APPLICATION FOR PERMISSION **UNDER SECTION 16 OF** THE TOWN PLANNING ORDINANCE (CAP.131)

For Official Use Only 請勿填寫此欄	Application No. 申請編號	A/TKO/125
	Date Received 收到日期	- 6 AUC 2021

Approved Tseur	ng Kwan O O	utline Zoning I	Plan No. S/T	KO/28
(d)		me and number of tutory plan(s)	the related		•			
1		關法定圖則的名稱)	→ 編號	•		-	•	
			~ vijia 27 a				•	
		f		"Open Space"				
(e)		nd use zone(s) involv	/ed	•	•			
	涉》	及的土地用途地帶				,		
	:		 	Temporary Publ	ic Vehicle Pa	· .		
		•	•	remporary rubi	ic verificie i a	·.		
	-							
(f)		rent use(s) 寺用途		•			,	
	2764	471324		(If there are any G	overnment inst	itution or comm	mity facilities	please illustrate on
				plan and specify the	e use and gross	floor area)		-
_			•	(如有任何政府、村	機構或社區設加	· 讀在圖則上顯	<u> 沃,並註明用</u>	途及總樓面面積)

Figure 5a: Location of the Connection Interface and the Catchment of the Project Site after Project Implementation

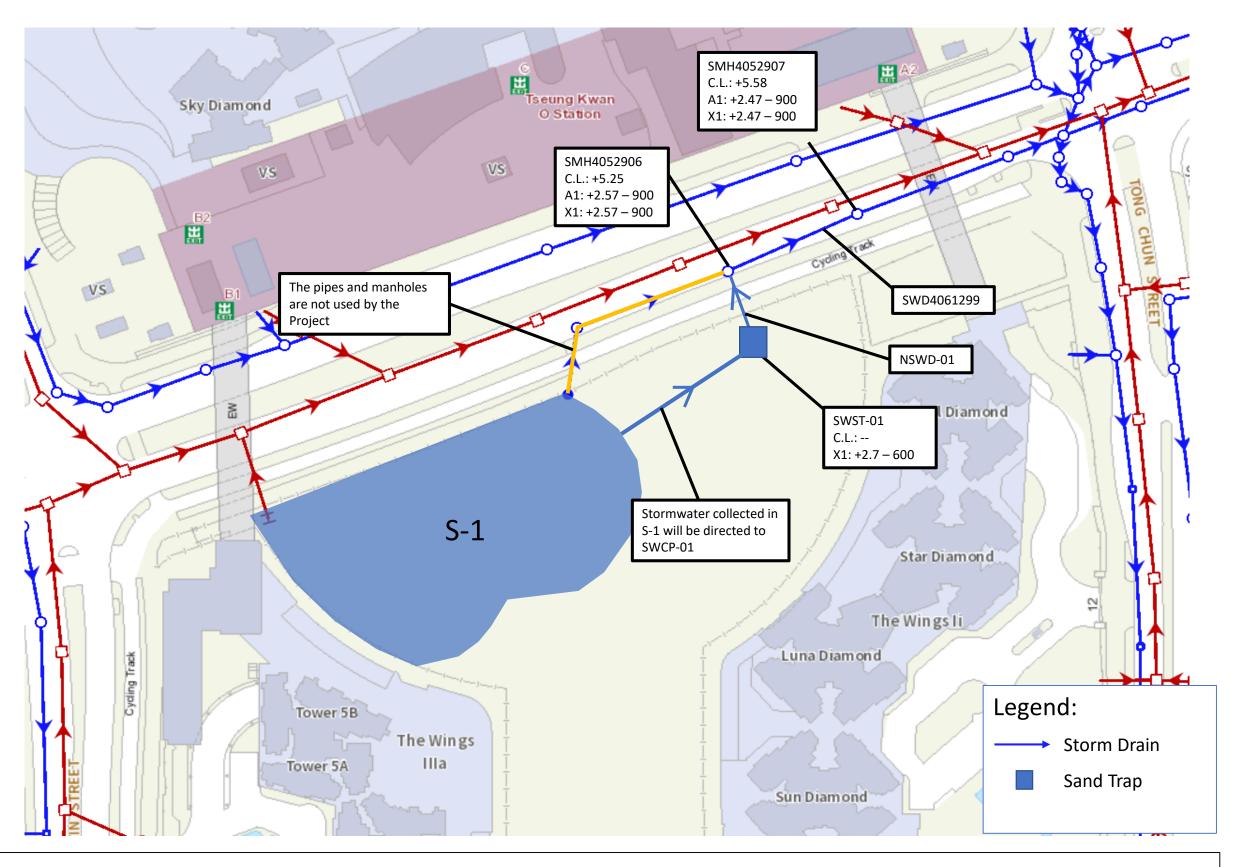
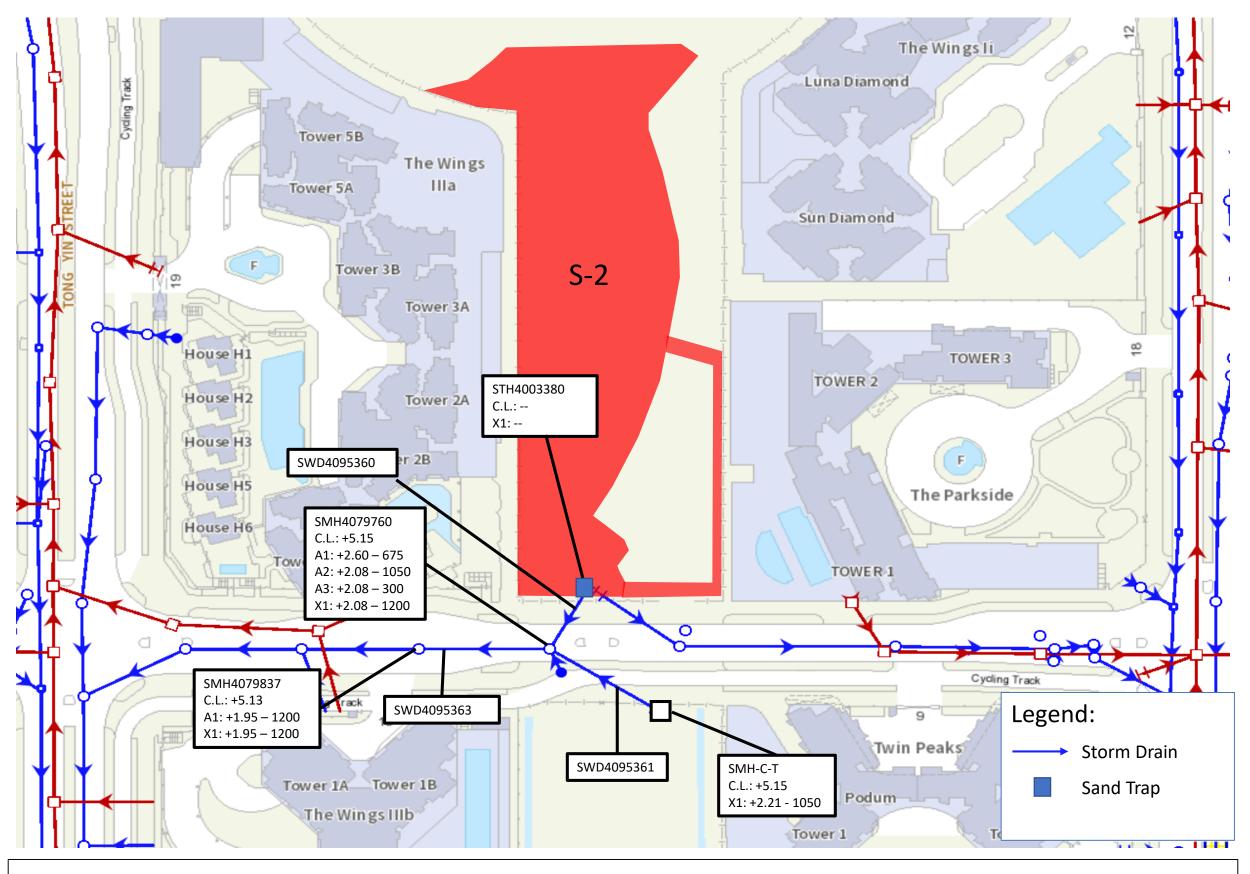
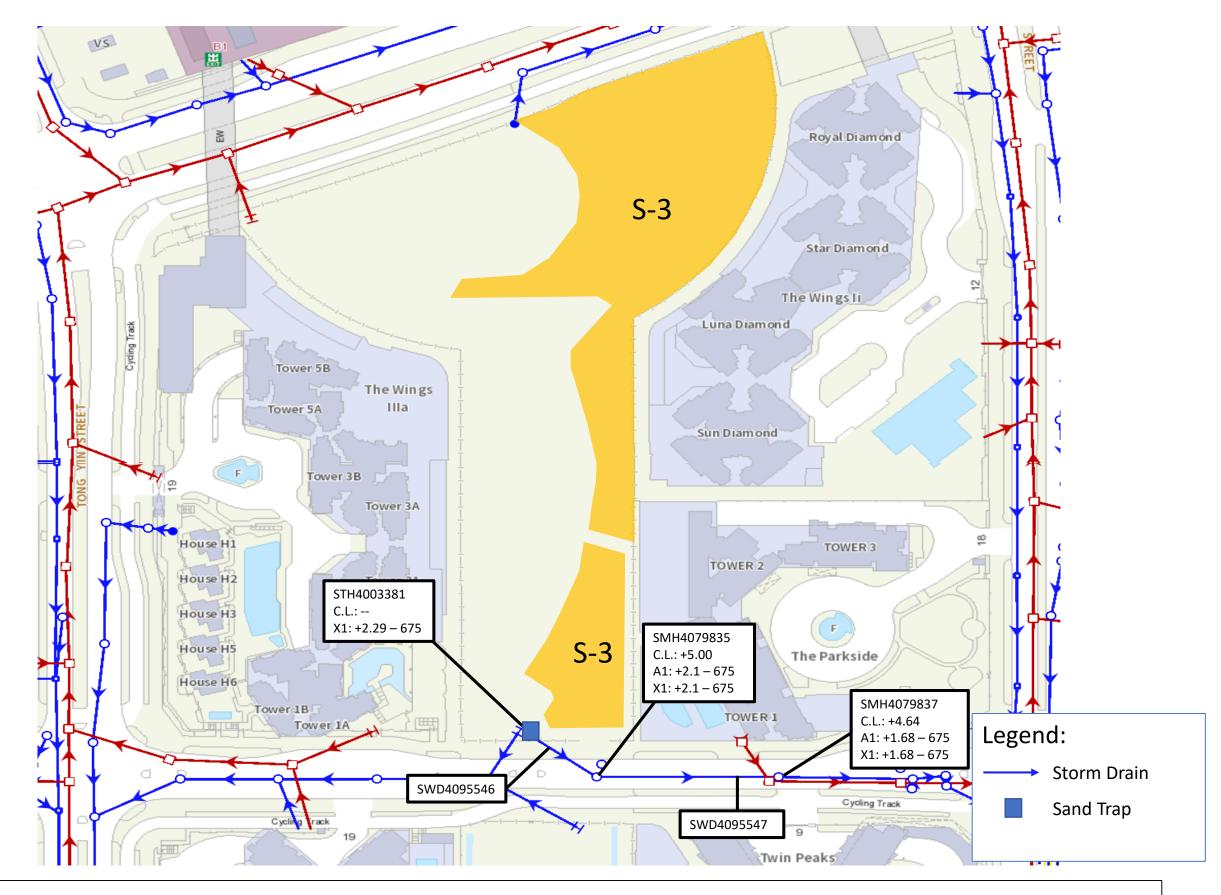
Comment	Response
1.	Drainage Services Department (DSD)	
ej.	Appendix IV- Drainage Impact Assessment Section 3.5.2 - For clarity and completeness, pipe size should be shown in Table 3.4. Details of pipe(s) and manhole(s) mentioned in Table 3.4 should be clearly indicated in drawing / plan. (Figure 4a) as appropriate.	Noted. Table 3.4 is revised and details of pipe(s) and manhole(s) mentioned in Table 3.4 are reflected in Figure 5b and Appendix 3 in the revised DIA report at Appendix A .
р.	Section 3.5.5 - The downstream manholes and pipe numbers as mentioned in this section to receive the flaw from catchments S-1, S-2 and S-3 should be clearly indicated in drawing/plan. Besides existing scenario, a drainage connection plan should be provided for future scenario.	The downstream manholes and pipes mentioned in Section 3.5.7 are indicated in Figure 5a-c in the revised DIA report at Appendix A . Location of the connection interface and the catchment of the project site after project implementation are shown in Figure 5a-c in the revised DIA report at Appendix A .

ပ်	Section 3.5.7 - A column should be added to indicate the size of pipes in Table3.5. Details of pipe(s) and manhole(s) mentioned in Table 3.5 should be clearly indicated in drawing / plan as appropriate.	Noted. Table 3.5 is revised and details of pipe(s) and manhole(s) mentioned in Table 3.5 are shown in Figure 5a-c in the revised DIA report at Appendix A.

Figure 3: Sewerage System Layout after Project Implementation

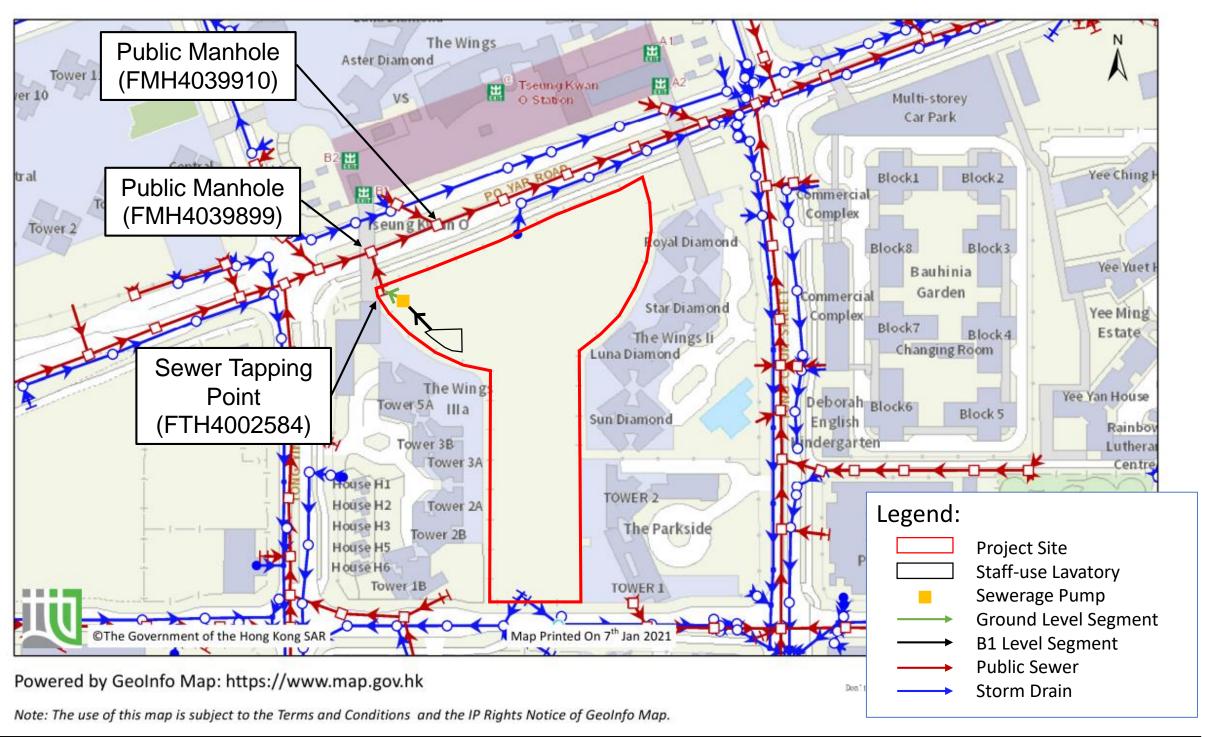
Comment	Response
		The total number of staff per day or state the number of shifts per day have been state in Appendix 1 and Section 3.2.2 in the revised SIA
· 	A sewerage connection plan should be provided.	report at Appendix B . Noted. Details of sewerage connection are indicated in Figure 3 in the revised SIA at Appendix B .

Figure 3: Distance Between Road Segments and the Project Boundary

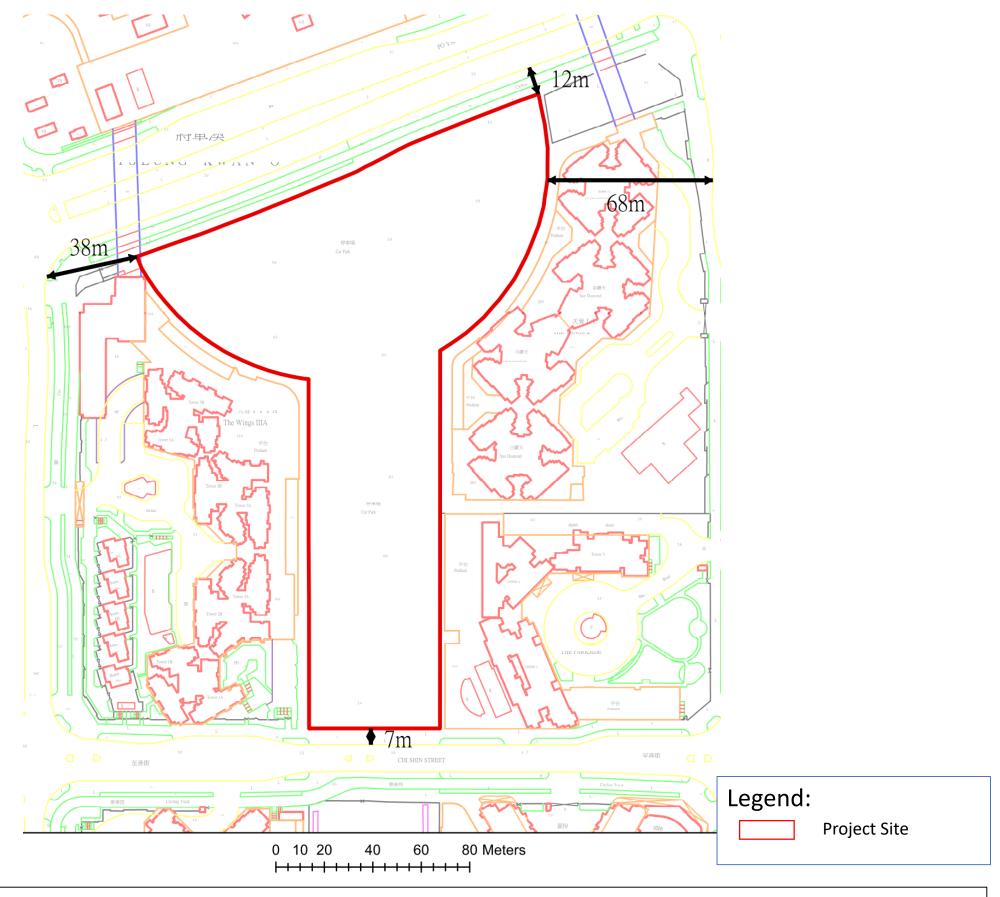
-i	S.2.2.25 – Please include a figure to indicate the measurement of shortest distances between the open space within the project site and the respective roads.	Noted. The shortest distances between the open space within the project site and the respective roads have been shown in Figure 3 in the revised PER at Appendix C.
